FINAL
YEAR 4 (2019) ANNUAL
MONITORING REPORT

**NEIGHBORS BRANCH/WALTON CRAWLEY BRANCH
STREAM & WETLAND RESTORATION SITE**

NCDMS Project No. 92872
Contract No. D09023S
USACE Action ID No. SAW-2009-917 & NCDWR Project No. 10-0122
SCO No. 08-07308-01
McDowell County, North Carolina

RE: Neighbors Branch/ Walton Crawley Branch Monitoring (DMS Project # 92879, Contract # D09023S)
Final Year 4 (2019) Annual Monitoring Report

Title:
**Current Conditions
 Plan View**

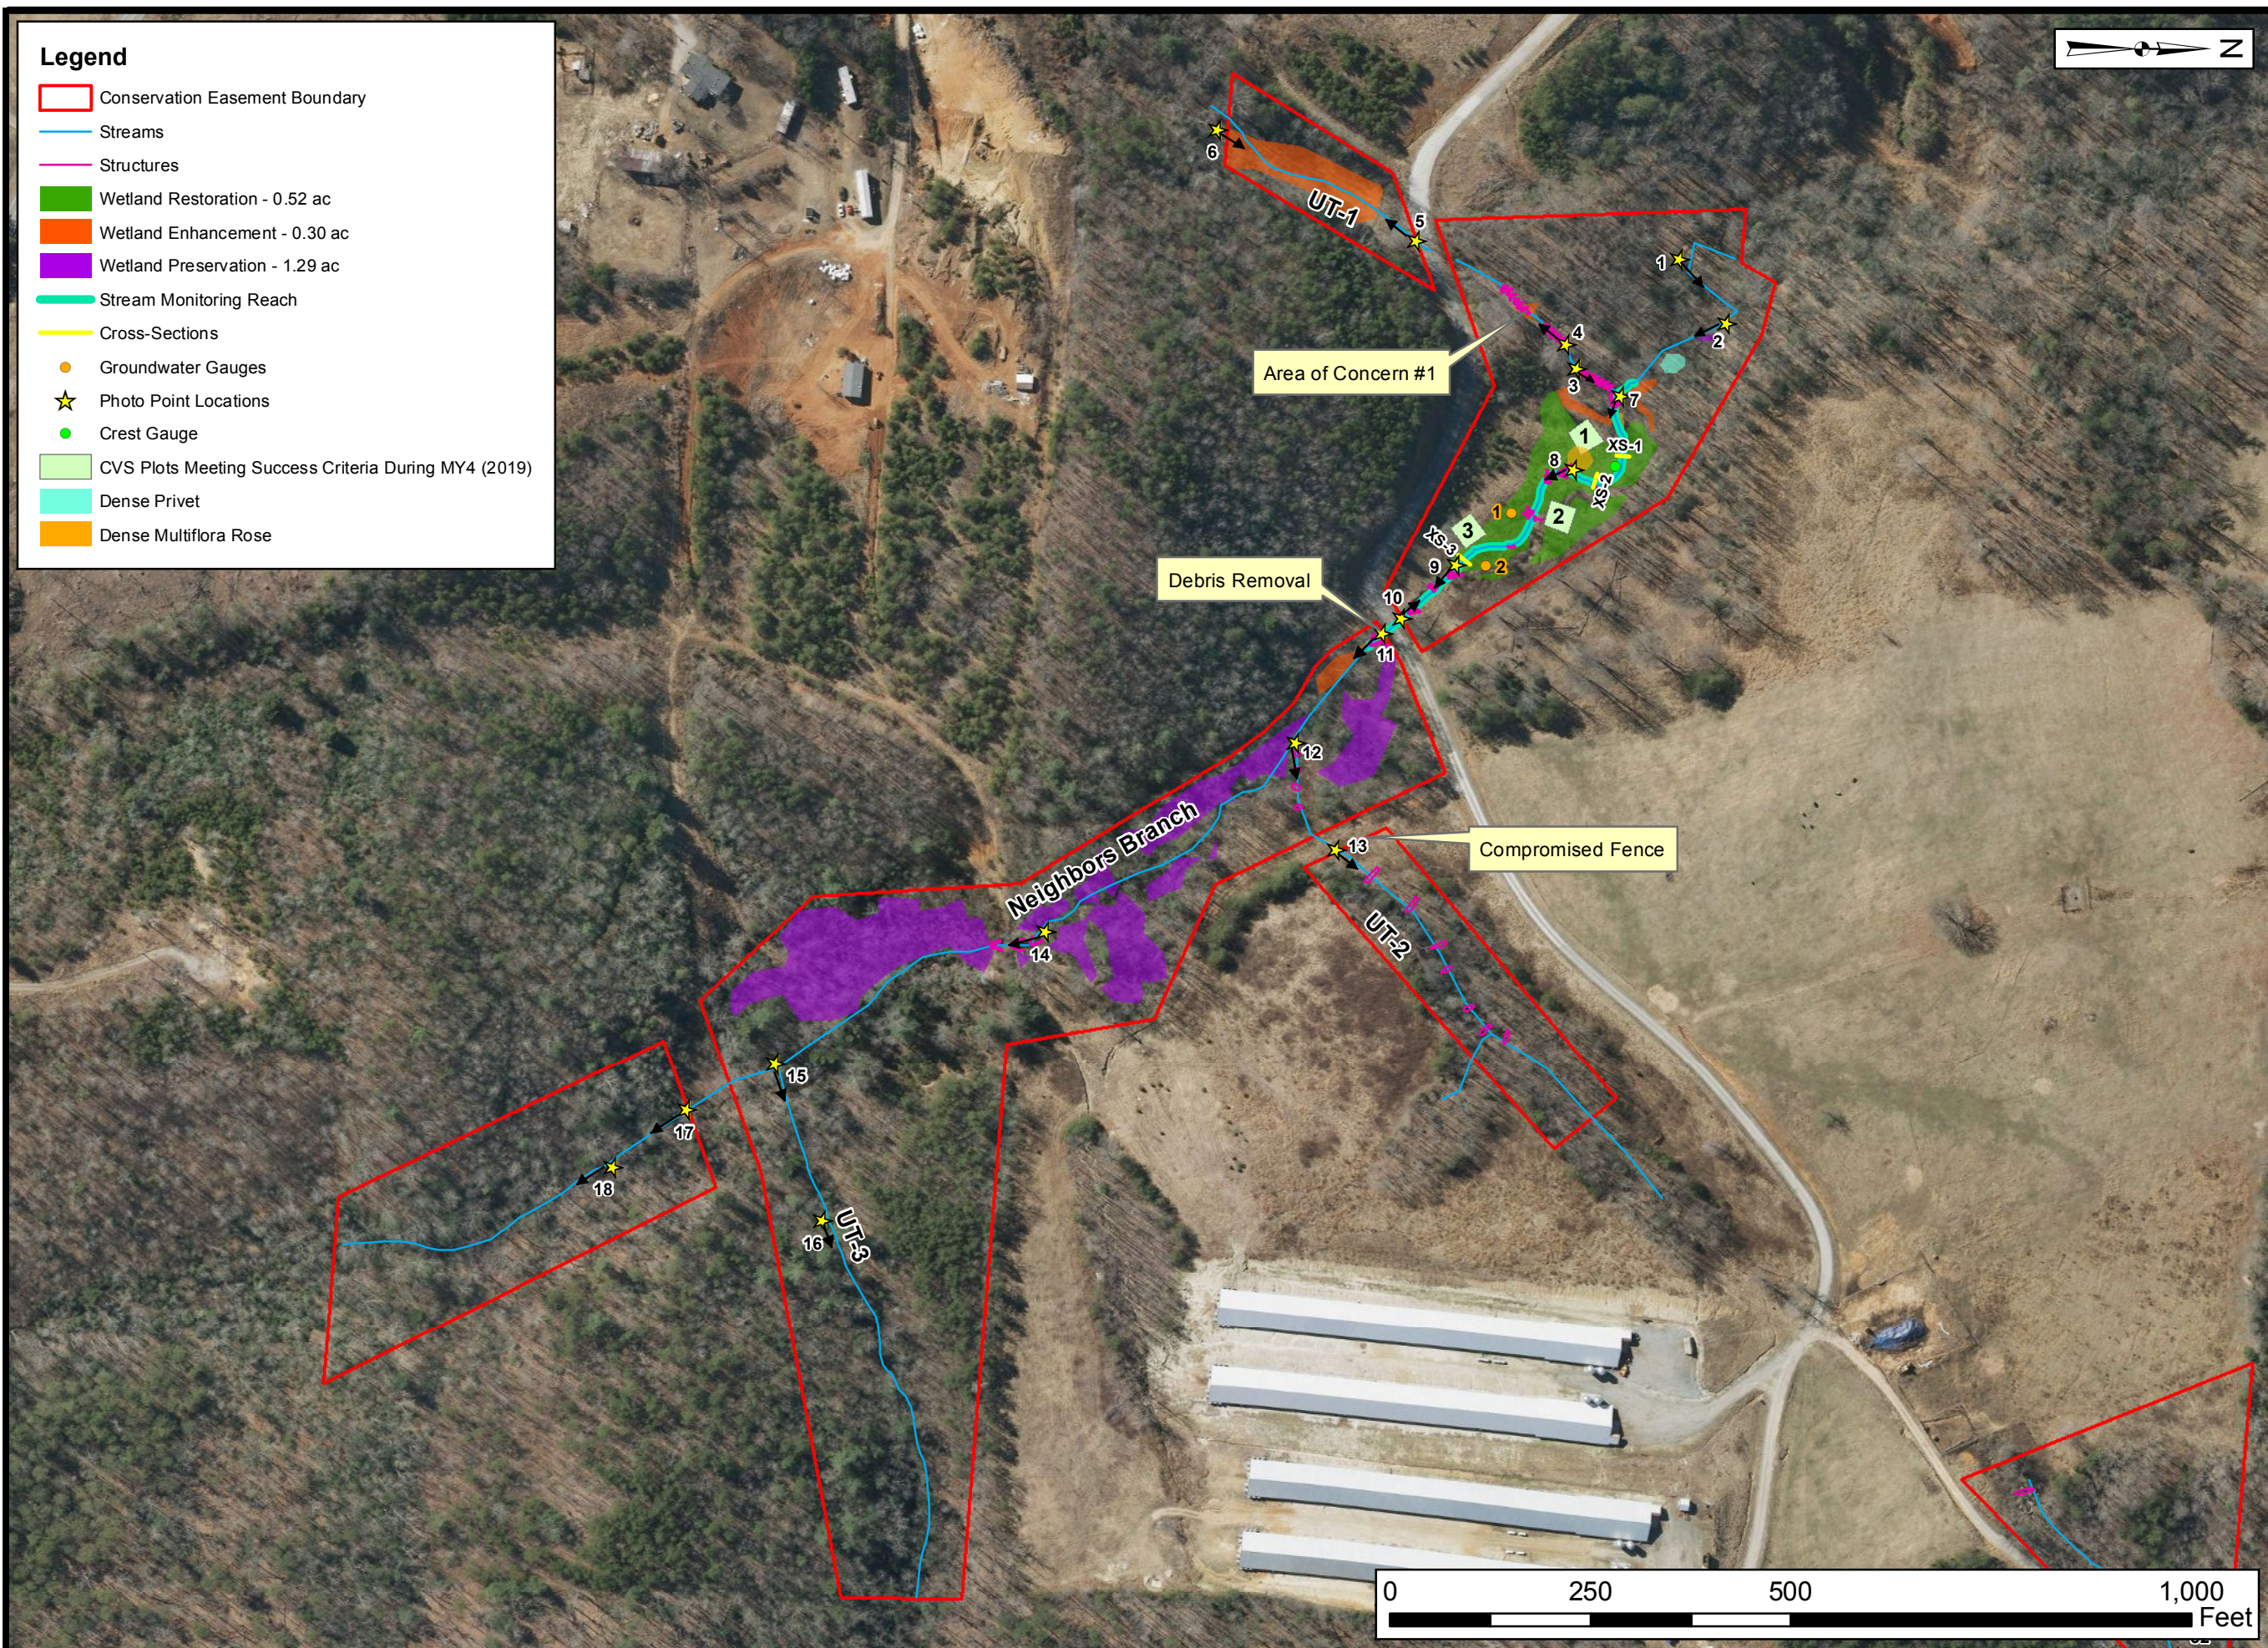
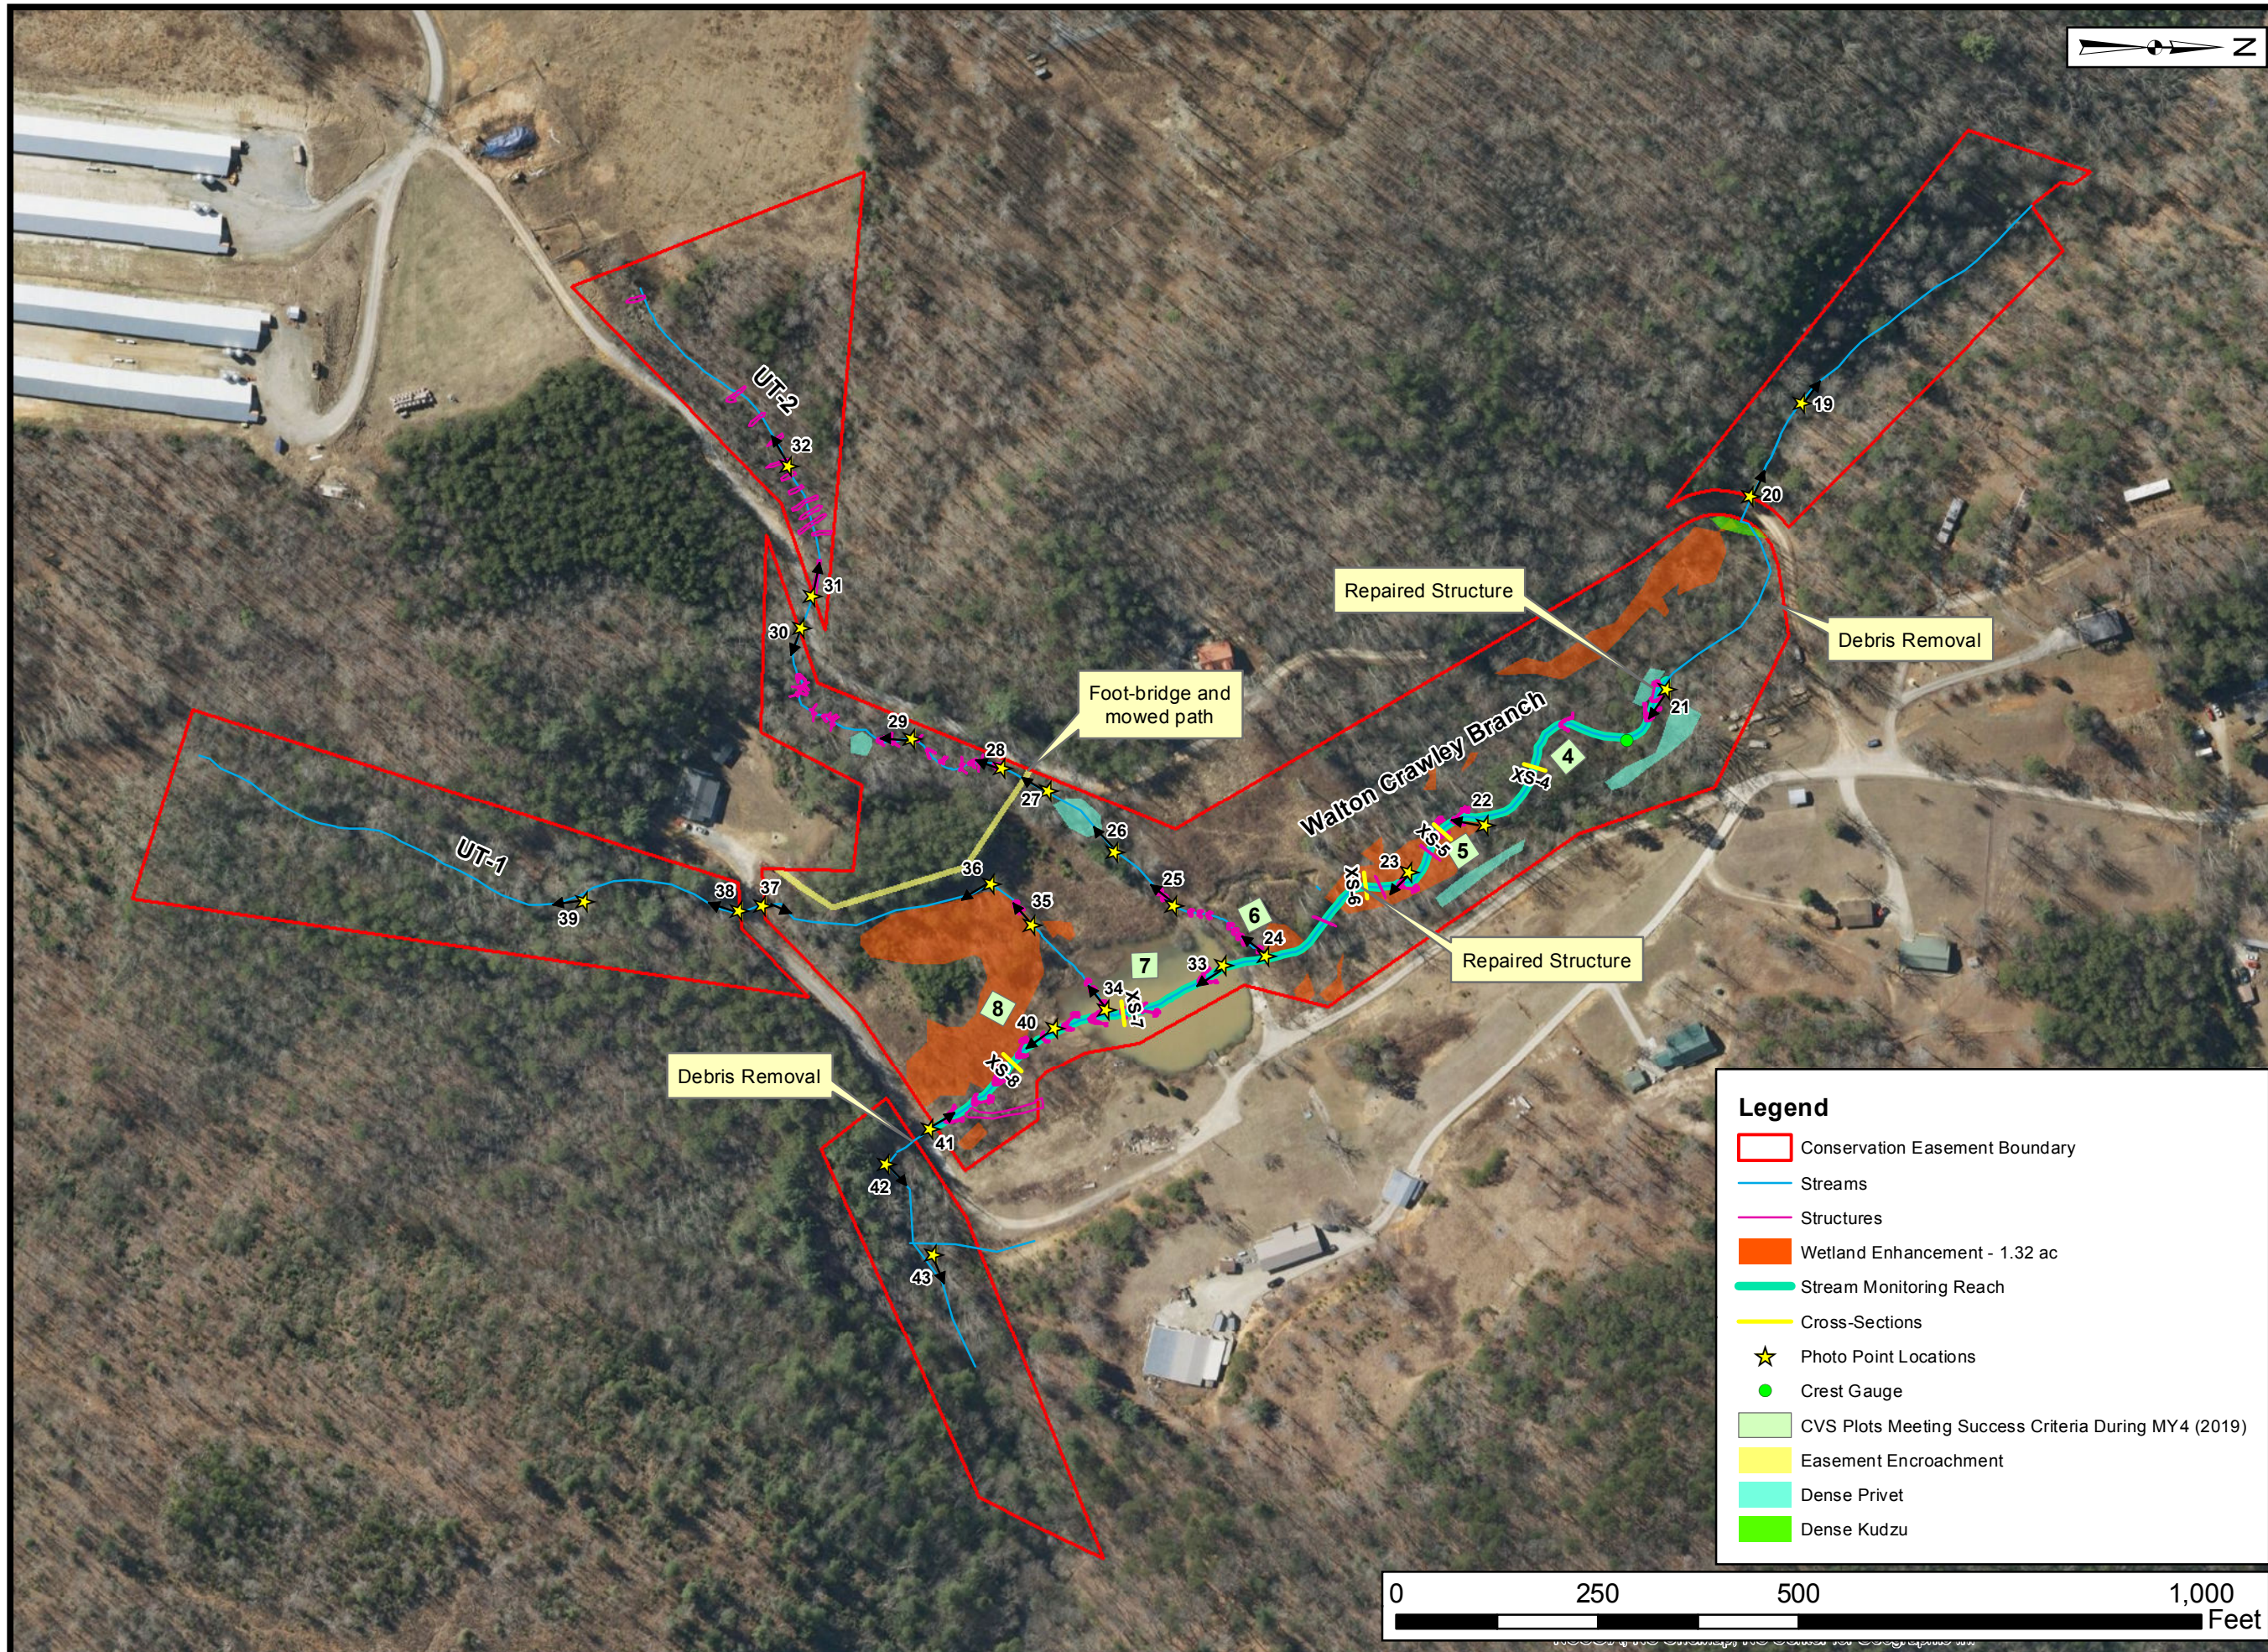
These items were added to table 2.
- CCPV: Please remove dense shrubby bushclover from CCPV. This species has not been high priority species in the past with the regulatory agencies. Please update Table 6 to exclude bushclover as well.

Shrubby bushclover occurrences were removed from the CCPV and table 6.
- CCPV: Please add the locations of debris removal and repaired structures to CCPV and add a callout (see attached map).

Callouts were added to highlight the locations of debris removal and repaired structures.
- Cross sections: The summary data on some of the cross sections does not match the Table 11 data. I think MY3 data may be showing on the graphs. Please verify and correct as necessary for all occurrences. Digital deliverable comment is referring to this as well.
